RE: **Lot 3 Block 9 Unit 22 SAD 228
6436 Picardia NW
Volcano Cliffs Subdivision
Grading and Drainage Plan
Engineers Stamp Date 11/5/2020 (D10D003Q3)**

Based upon the information provided in your submittal received 11/9/2020, this plan is approved for Grading Permit.

DRAINAGE AND TRANSPORTATION INFORMATION SHEET (REV 6/2018)

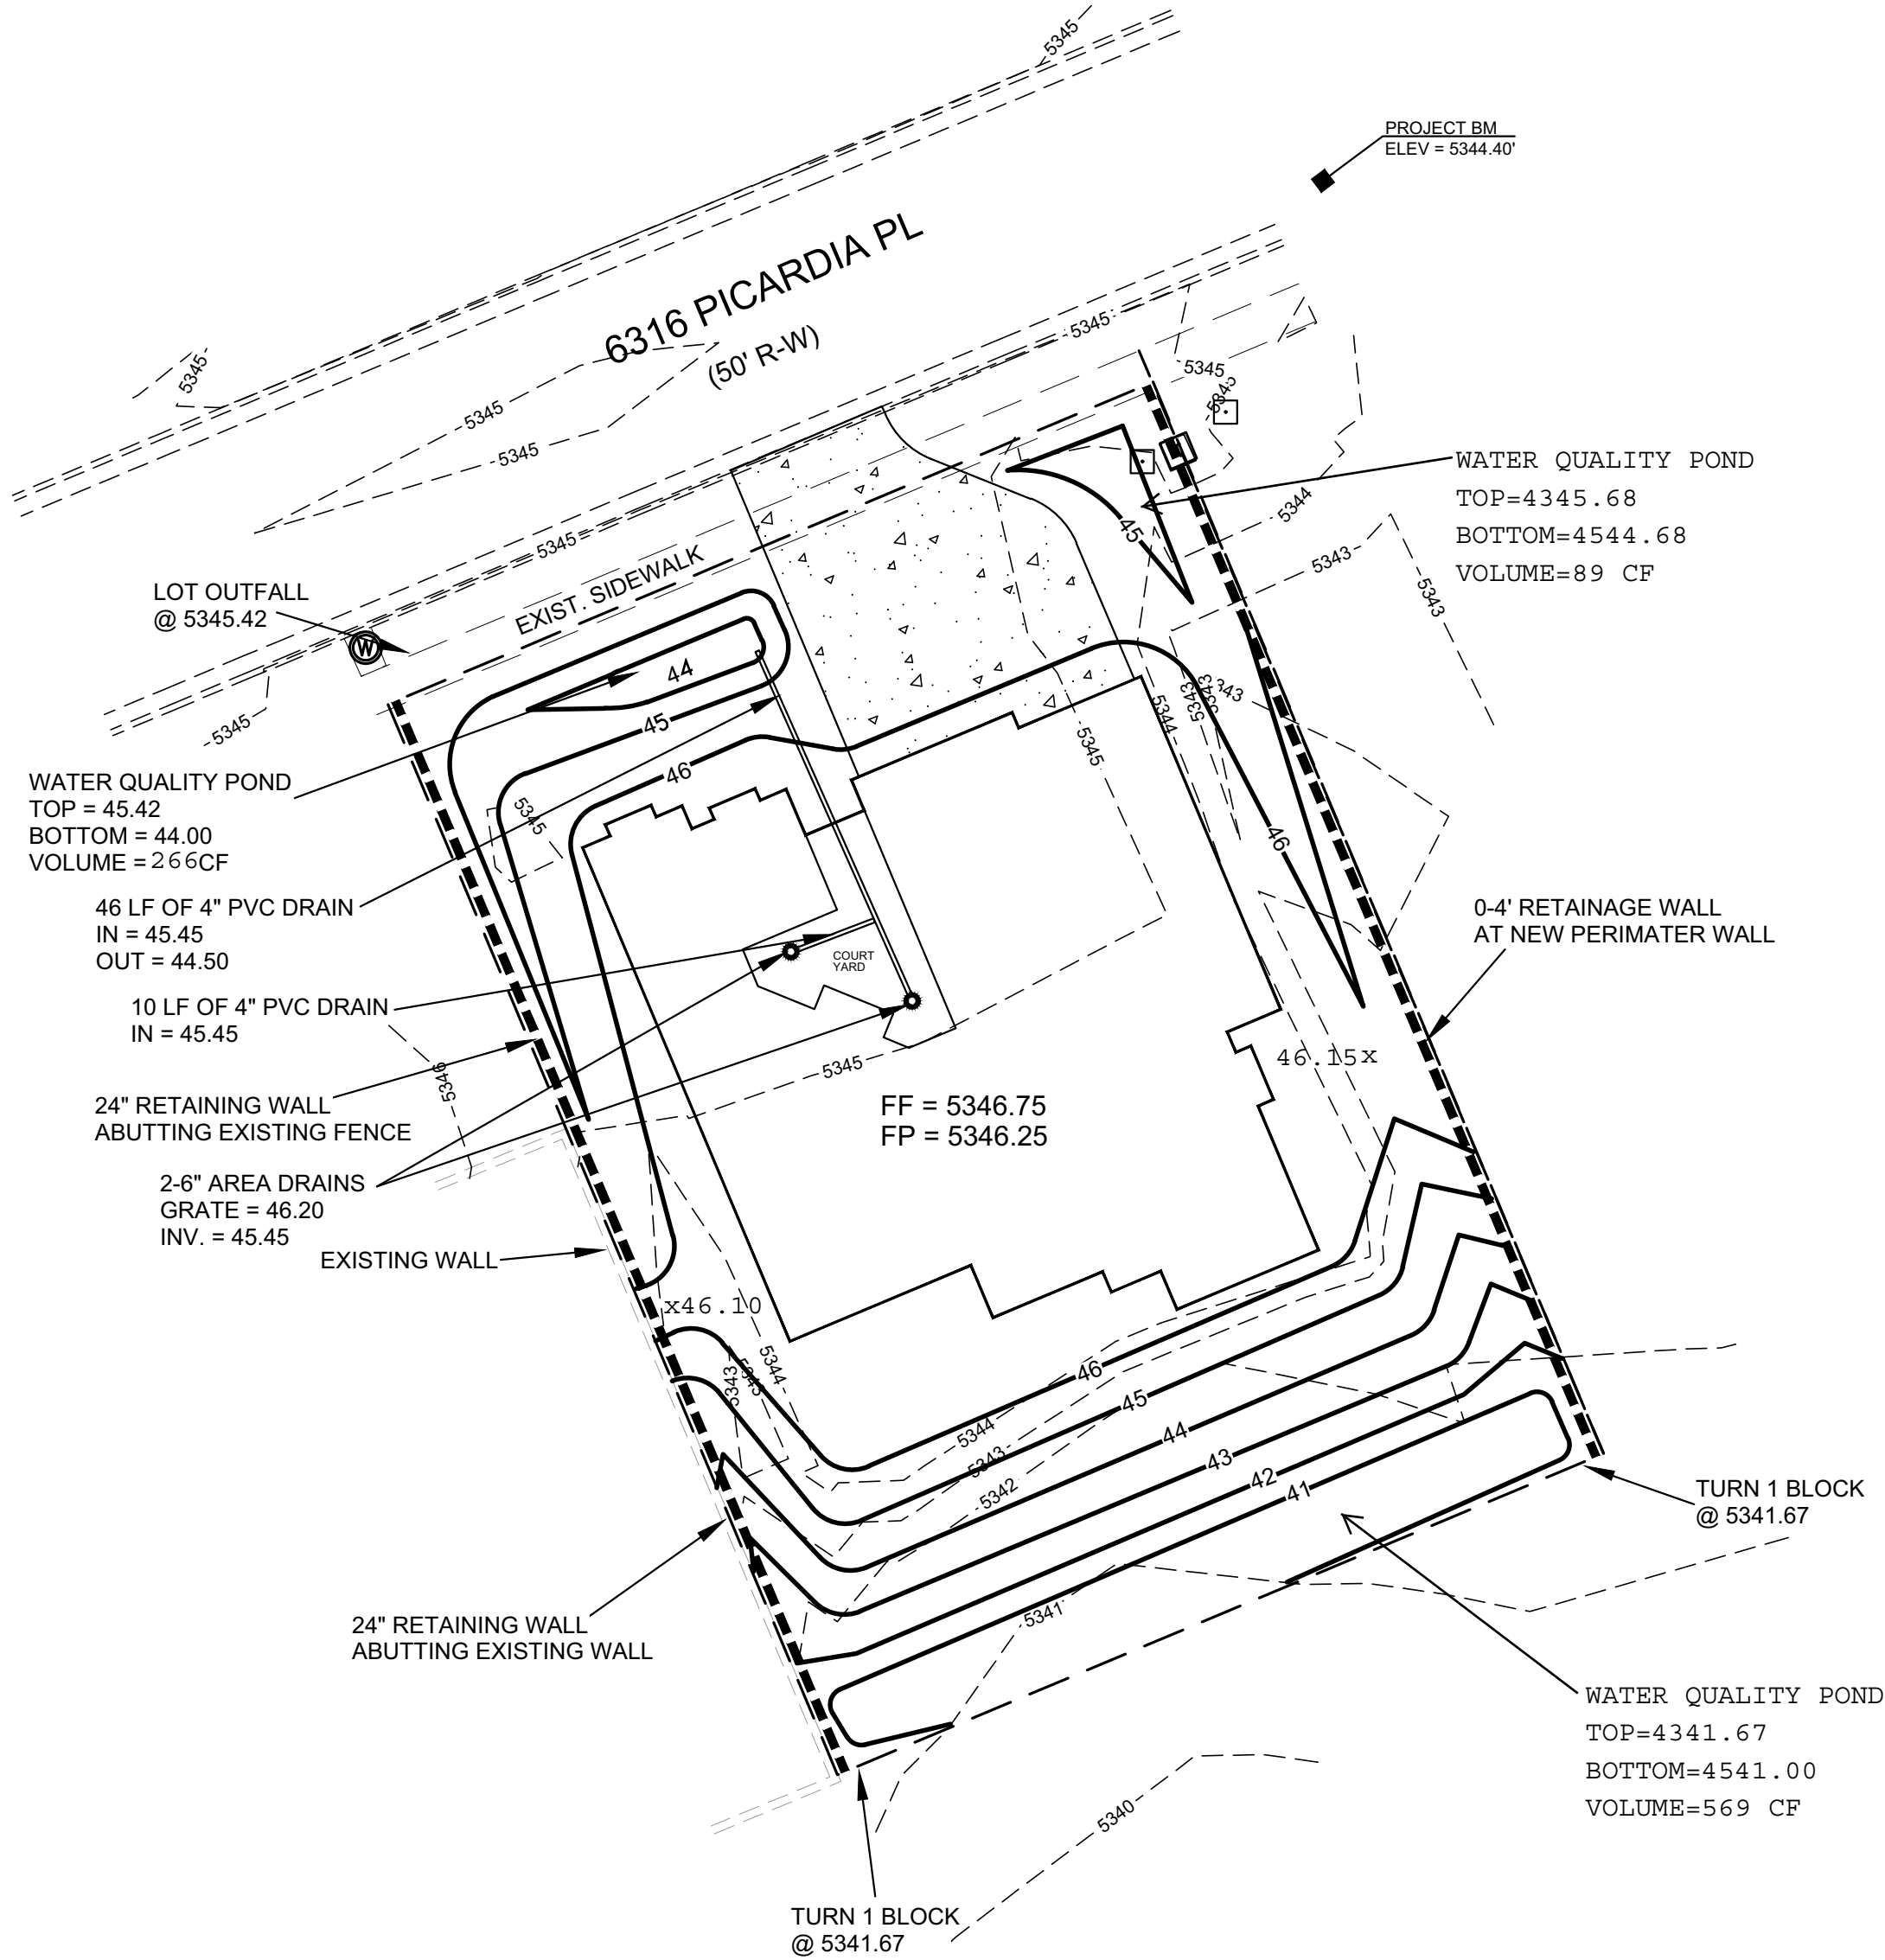
Prior to Building permit approval a Pad Certification will be required, provided by the Engineer or a registered Land Surveyor.

Advise the owner contractor not to use dirt as a ramp to climb the curb, use lumber or crusher fines for this purpose.

Reiterate to the Owner/Contractor that a separate permit for a garden/retaining wall must be obtained with the approved G&D plan and Pad Certification. Also, if a swimming pool is to be placed the grading and drainage plan will change and will need to be resubmitted.

Prior to Certificate of Occupancy release, Engineer Certification per the DPM checklist is required.
